## STAFF REPORT

**RE:** PUBLIC HEARING: **Planned Area Development (PAD) 15-04 Homestead North Major Amendment:** A request by Shane Graser representing Starwood Land Ventures to amend the existing PAD of Homestead North Parcels 15, 16, 18, and 19, increasing the total number of lots by 113 lots, enhanced street sections, and additional residential design standards. **(Discussion and Action).**

**Proposed Modified Section:**

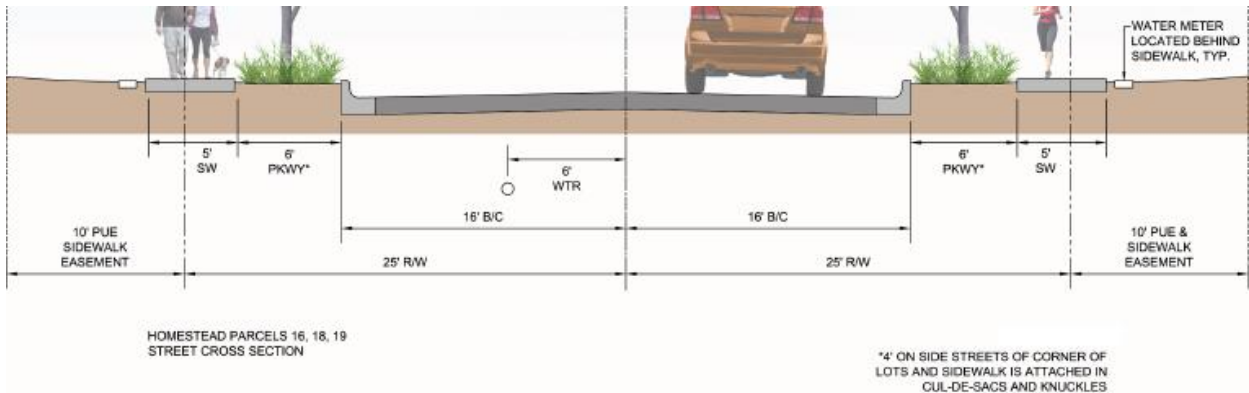
**Staff Analysis:** The proposed PAD Amendment includes commitments that, in staff’s assessment, enhance the circulation character of the parcels. The proposed street sections offer prominent tree-lined streets by bringing the trees closer to the street and offers greater availability of shade on the sidewalk. See the comparison of the proposed section and the City Standard section below.

It is often noted that bringing trees closer to the street has the effect of traffic calming (slowing traffic speeds).

Maintenance of the landscaping within the ROW will need to be designated in the recorded documents at the time of re-plat.

- 50’ R/W Width
- 28’ Pavement Width
- Vertical curb depicted – ultimately designed to convey stormwater
- 6’ landscape strip between curb and sidewalk (both sides)
- 5’ sidewalks (both sides)
  - Sidewalks will require approx. 2’ easements on front of lot lines as part of the 10’ Public Utility Easement (PUE)
  - Sidewalk will reduce to 4’ and be attached to curb at the knuckles and cul-de-sacs
- 32’ from back of curb to back of curb
- On-Street Parking: 1-side
- Parcel 15 only offers curb-separated sidewalk on one side due to existing utilities in the ground
